RE: **Proposed Sheetz at Airport Road & Seminole Trail**
ARB-2020-39 and ARB-2020-46
Sheetz Initial Site Plan and Architectural Review Board Action Letter

Architectural Review Board Workshop Plans and Sketches

AIRPORT ROAD SHEETZ
INITIAL SITE PLAN
ALBEMARLE COUNTY, VIRGINIA

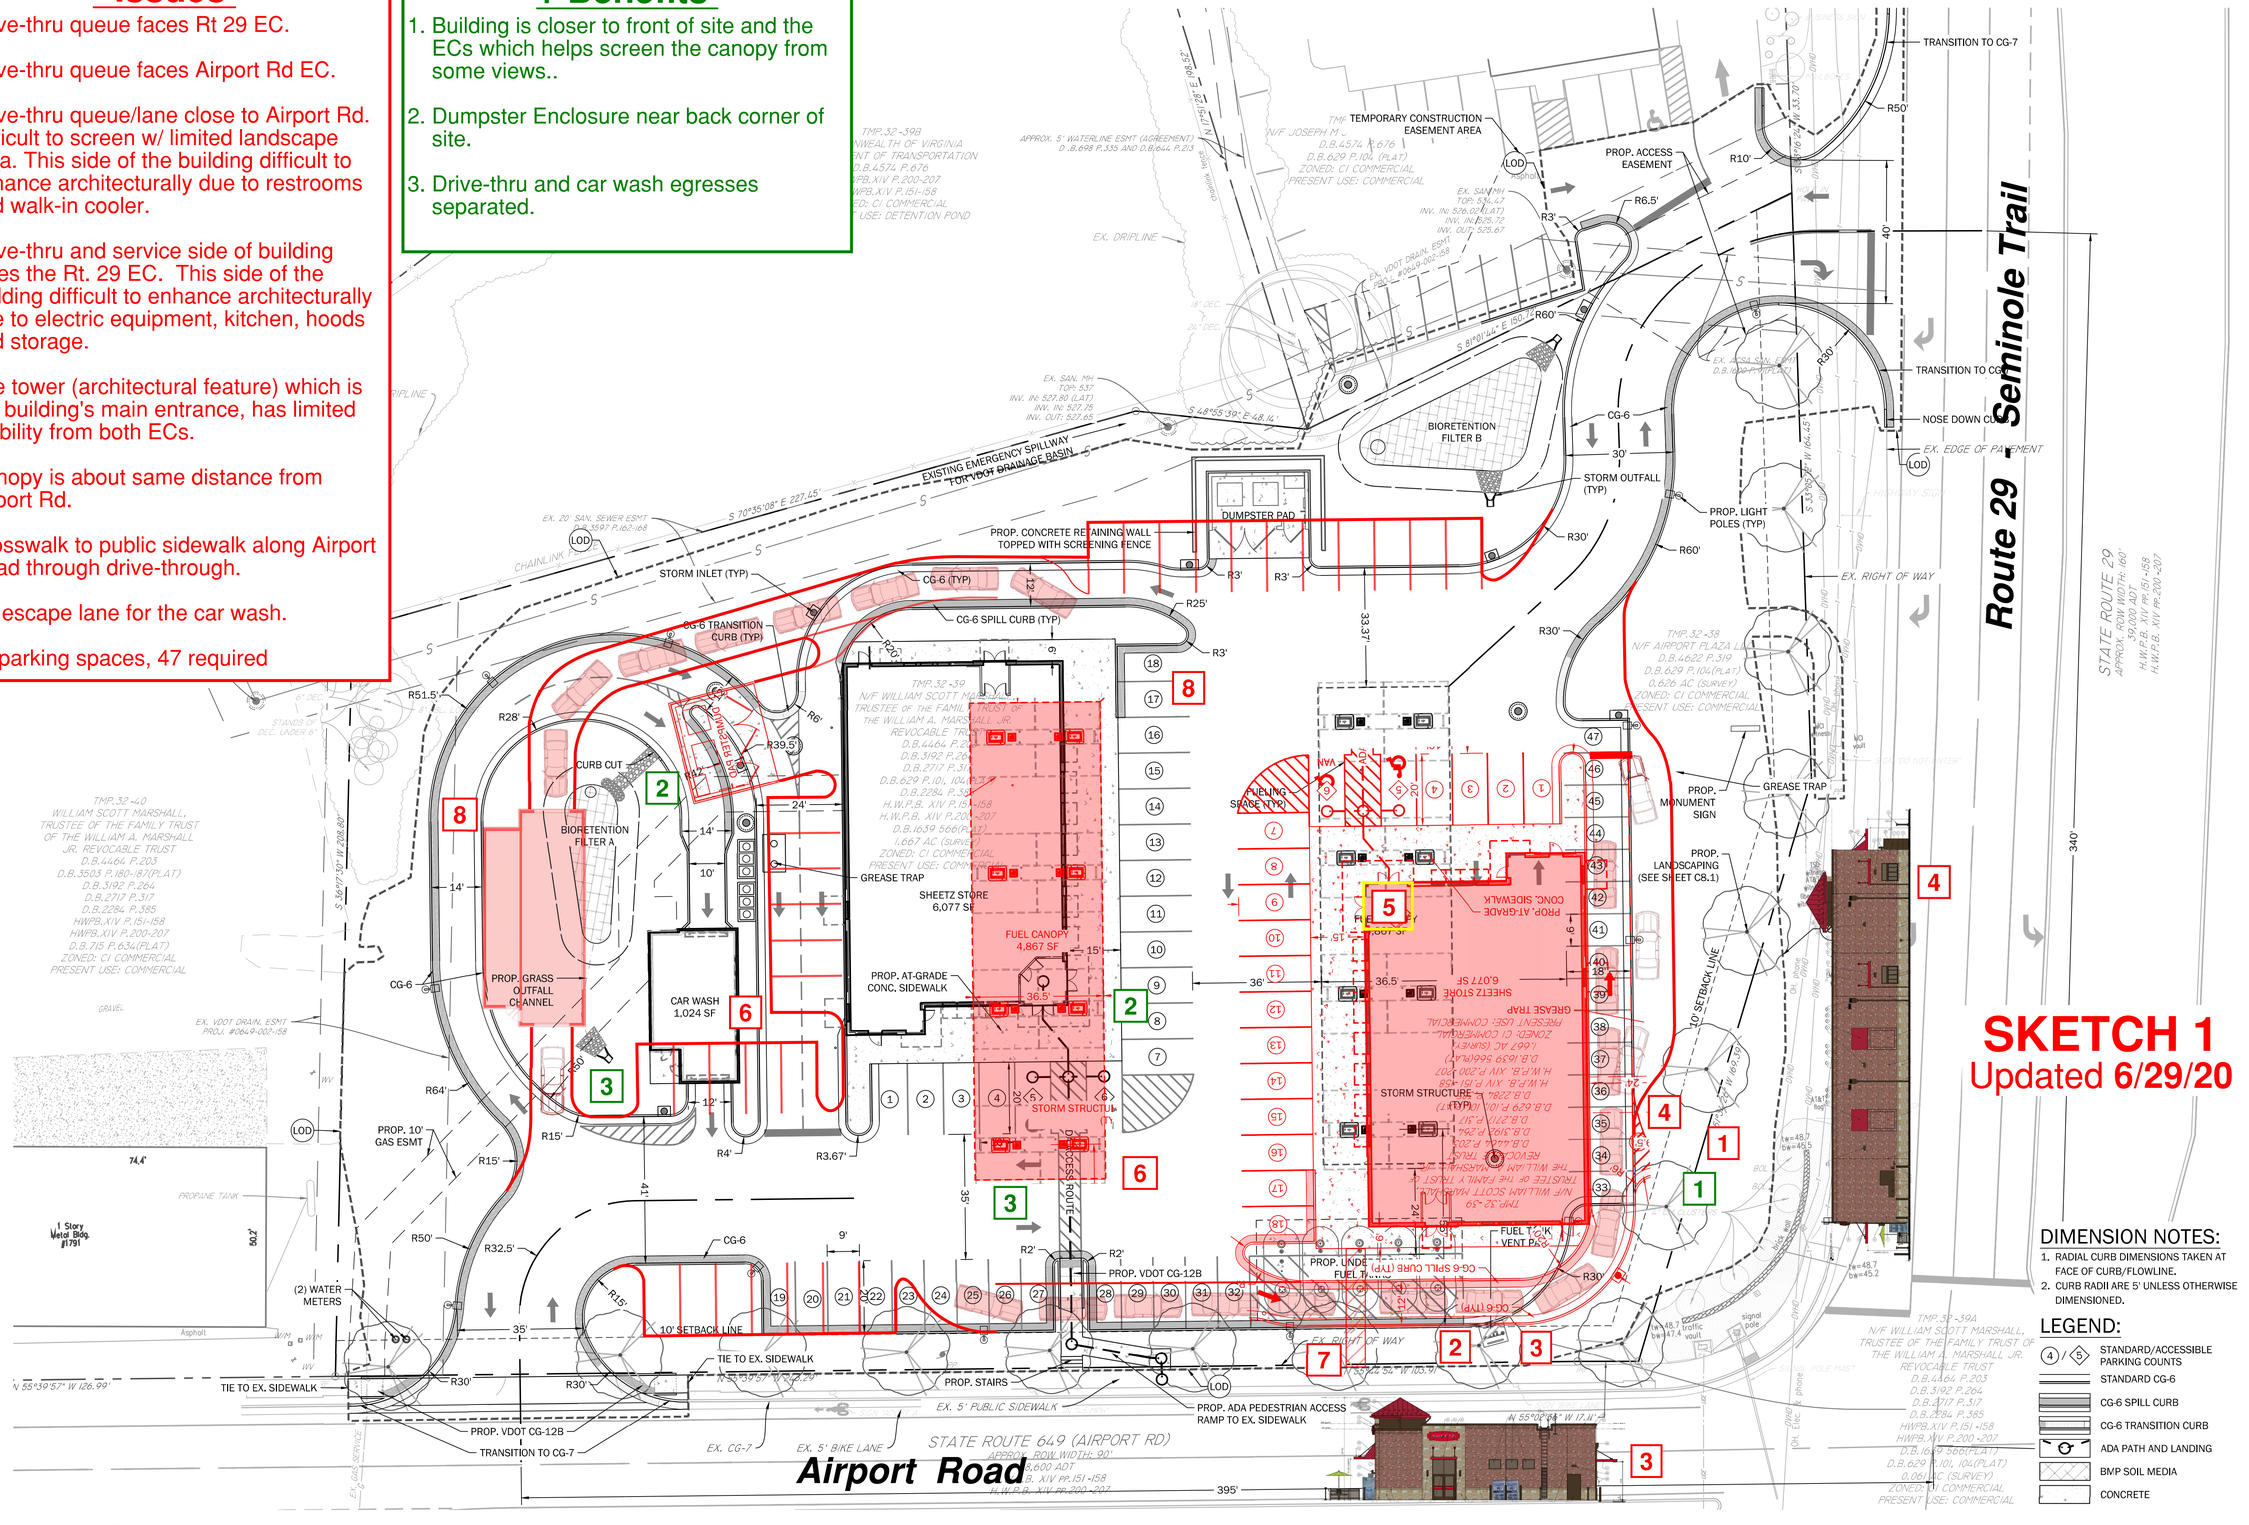
- Issues

1. Drive-thru queue faces Rt 29 EC.
2. Drive-thru queue faces Airport Rd EC.
3. Drive-thru queue/lane close to Airport Rd. Difficult to screen w/ limited landscape area. This side of the building difficult to enhance architecturally due to restrooms and walk-in cooler.
4. Drive-thru and service side of building faces the Rt. 29 EC. This side of the building difficult to enhance architecturally due to electric equipment, kitchen, hoods and storage.
5. The tower (architectural feature) which is the building's main entrance, has limited visibility from both ECs.
6. Canopy is about same distance from Airport Rd.
7. Crosswalk to public sidewalk along Airport Road through drive-through.
8. No escape lane for the car wash.
9. 47 parking spaces, 47 required

+ Benefits

1. Building is closer to front of site and the ECs which helps screen the canopy from some views..
2. Dumpster Enclosure near back corner of site.
3. Drive-thru and car wash egresses separated.

SKETCH 2
Updated 6/29/20

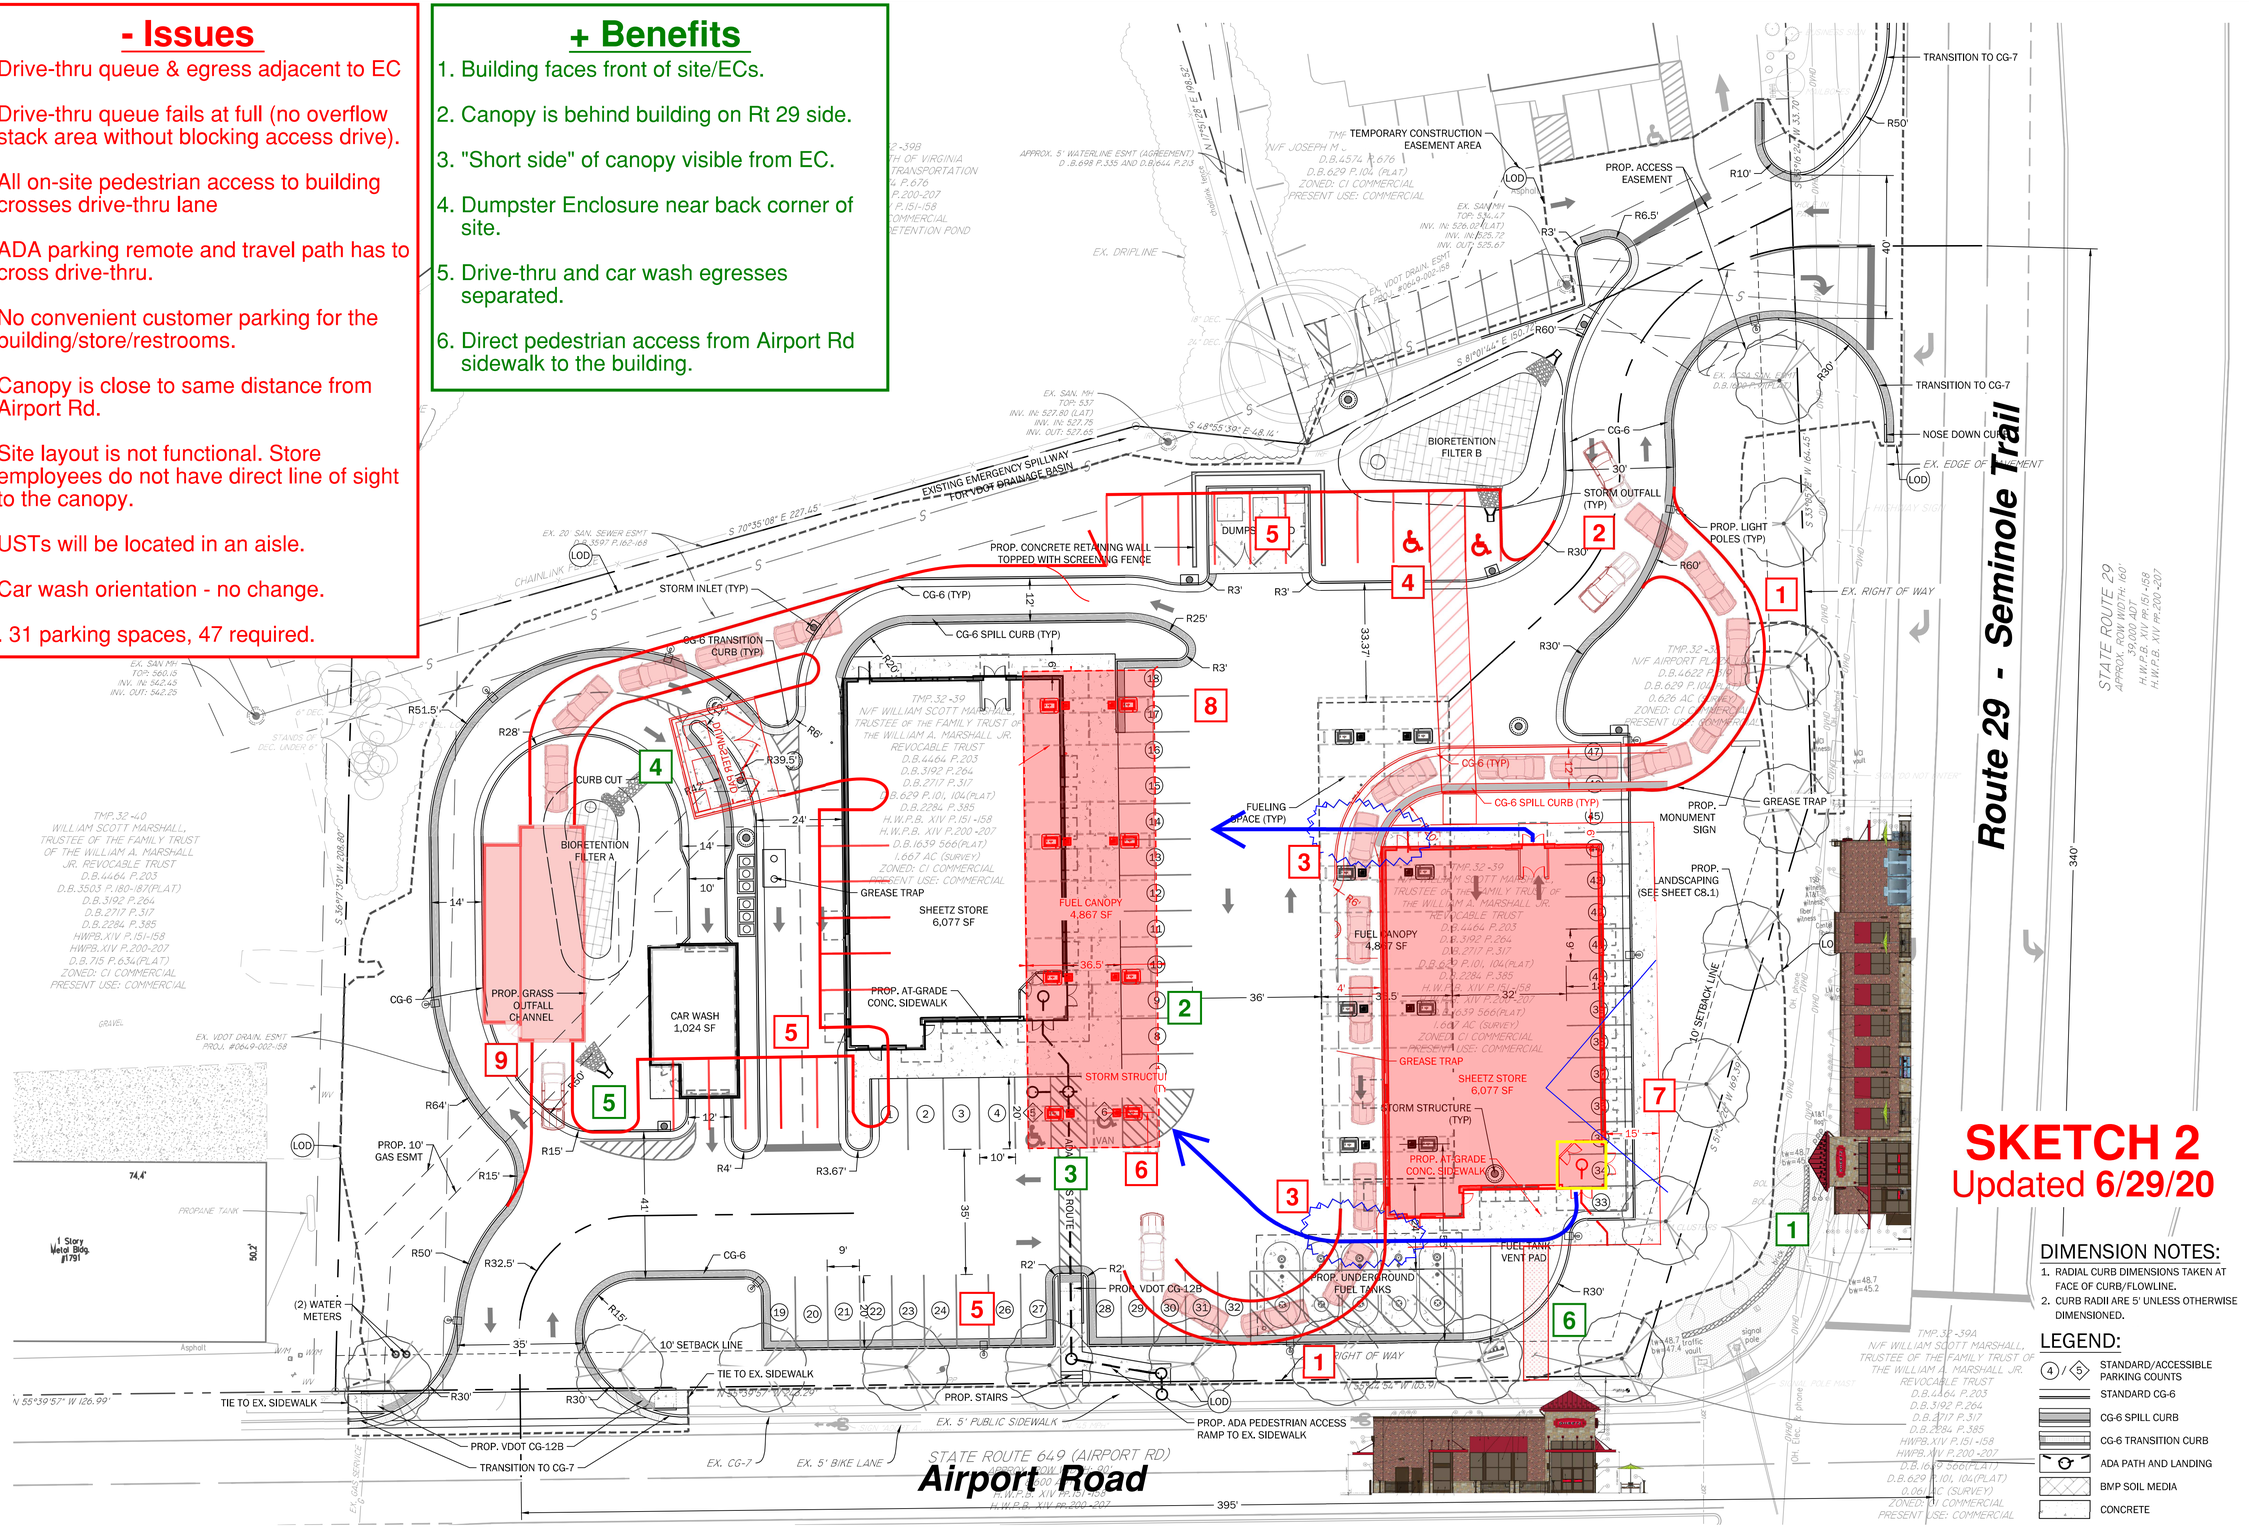
- Issues

1. Drive-thru queue & egress adjacent to EC
2. Drive-thru queue fails at full (no overflow stack area without blocking access drive).
3. All on-site pedestrian access to building crosses drive-thru lane
4. ADA parking remote and travel path has to cross drive-thru.
5. No convenient customer parking for the building/store/restrooms.
6. Canopy is close to same distance from Airport Rd.
7. Site layout is not functional. Store employees do not have direct line of sight to the canopy.
8. USTs will be located in an aisle.
9. Car wash orientation - no change.
10. 31 parking spaces, 47 required.

+ Benefits

1. Building faces front of site/ECs.
2. Canopy is behind building on Rt 29 side.
3. "Short side" of canopy visible from EC.
4. Dumpster Enclosure near back corner of site.
5. Drive-thru and car wash egresses separated.
6. Direct pedestrian access from Airport Rd sidewalk to the building.

Revisions to Original
Updated **6/29/20**

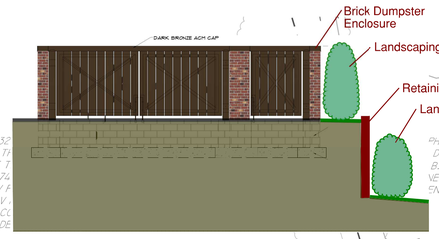
- Issues

1. Canopy in front of building from Rt 29 perspective. *Reduced square footage of gas canopy by 400 s.f.. Reduced number of fueling dispensers from 8 to 6 to further reduce the scale of the gas canopy.*
2. Dumpster enclosure along interior lot line but still in view from EC. *Added retaining wall to reduce the overall height and allow for some terraced landscaping for screening and to break up the mass.*
3. Canopy is close to same distance from Airport Rd.
4. No practical option to rotate car wash. (Option for site-built shown.) *The west elevation will be screened with landscaping. Windows facing east creates more of an attractive view from the site.*
5. USTs remain along Airport Rd side. (Vents can be screened w/ landscaping)
6. 47 parking spaces, 47 required.

Flip and shift dumpster enclosure to provide more landscape screening area

Car wash may be changed from modular to site-built for more options to customize the elevations

21' reduced island spacing

Pumps reduced from 8 to 6

1. "Customer oriented" building elevations oriented to both ECs. Entrance feature (tower) is functional and face the corner.
2. Drive-thru queue generally behind the building, not adjacent to ECs.
3. "Short side" of canopy closest to and faces the more sensitive EC/Airport Rd.
4. Dumpster Enclosure can be screened with landscaping.
5. Drive-thru and car wash can share escape lanes reducing impervious areas.
6. Large landscape area at Rt 29 frontage preserved.
7. ADA parking at building.
8. Canopy mass and number of pumps reduced.

PROPOSED
CANOPY ELEVATION
Revised Site Plan

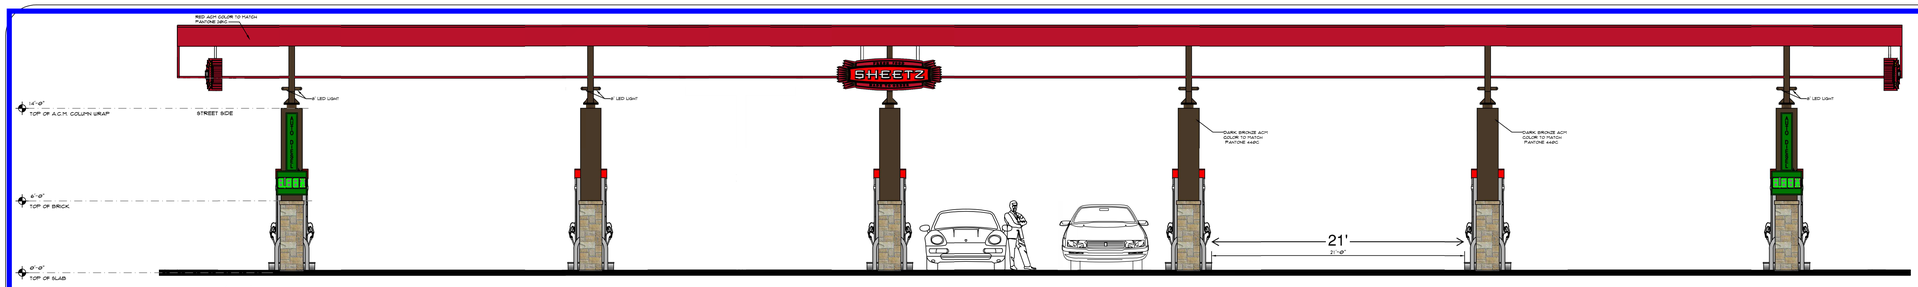
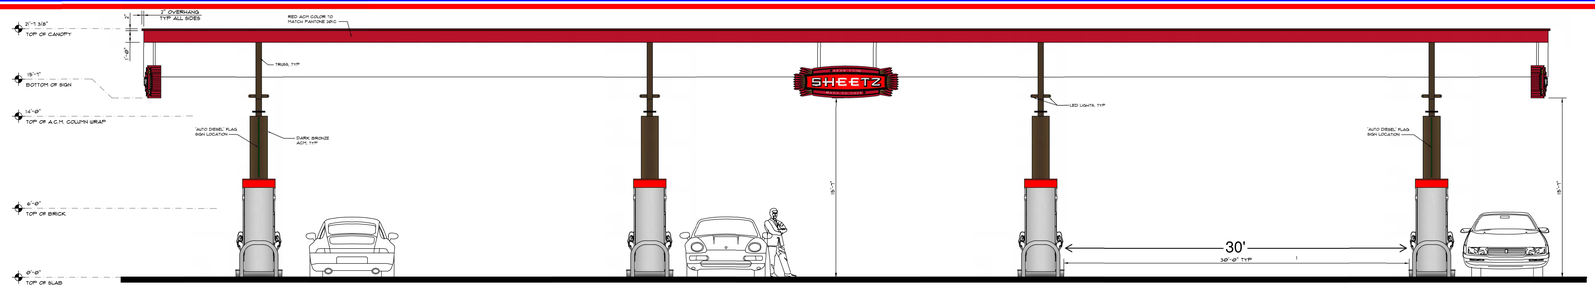
Overall Length: 140.25'

Spacing Between Islands: 21'

Overall Length: 133.33'

Spacing Between Islands: 30'

PROPOSED
CANOPY ELEVATION
Revised Site Plan

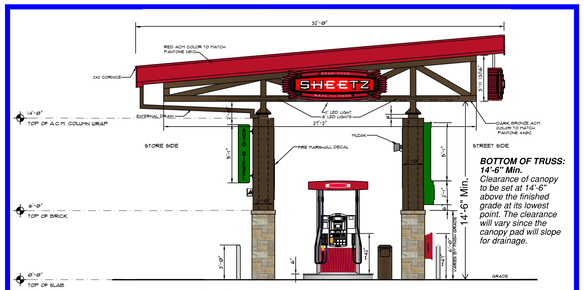
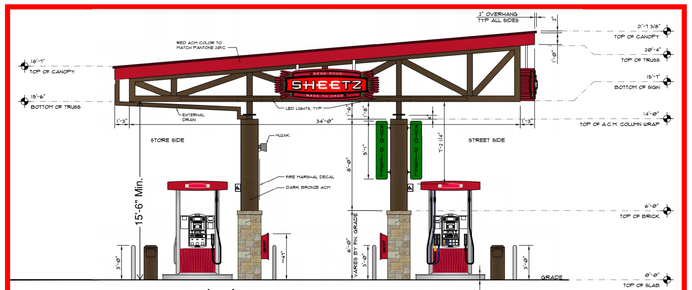
Overall Width: 31.83'

Overall Width: 36.50'

PROPOSED
CANOPY PLAN
Revised Site Plan

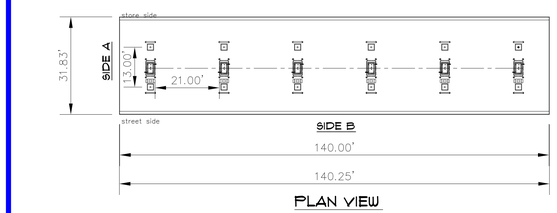
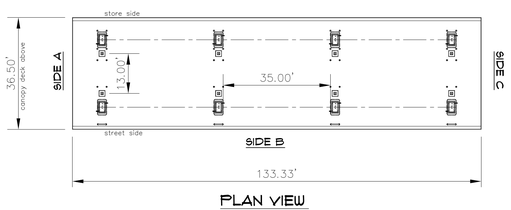
31.83' X 140.25'

36.50' X 133.33'
